Proposal for Supplement 2 to the original series of UN Regulation No. 148 (Light-Signalling Devices)

Submitted by the Working Party on Lighting and Light-Signalling*

Supplement 2 to the original series of UN Regulation No. 148 on Light-Signalling Devices (LSD)

"Figure A3-I:
**Standard light distribution for front and rear position-, parking-, end-outline marker-,
 stop- and direction indicator lamps**

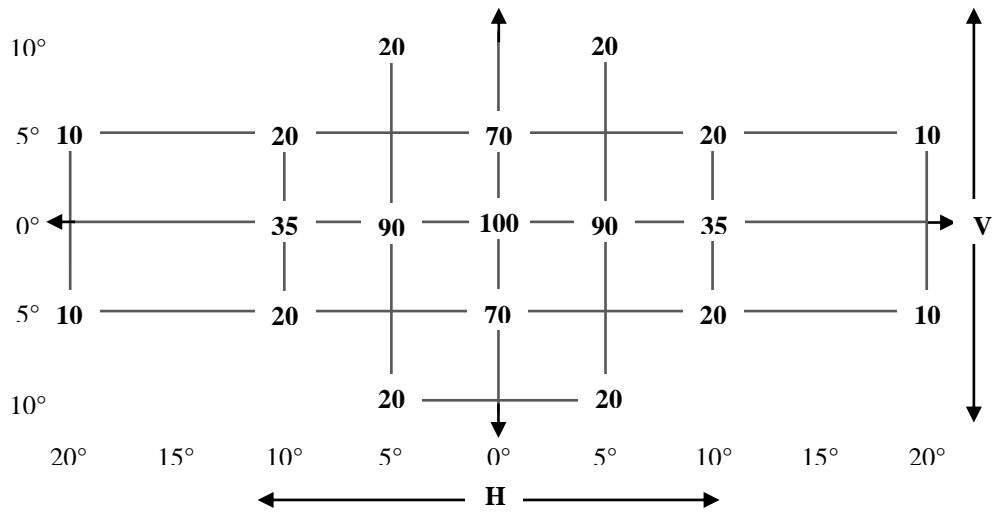
Annex 3, paragraph 2.1., figure A3-I, amend to read:
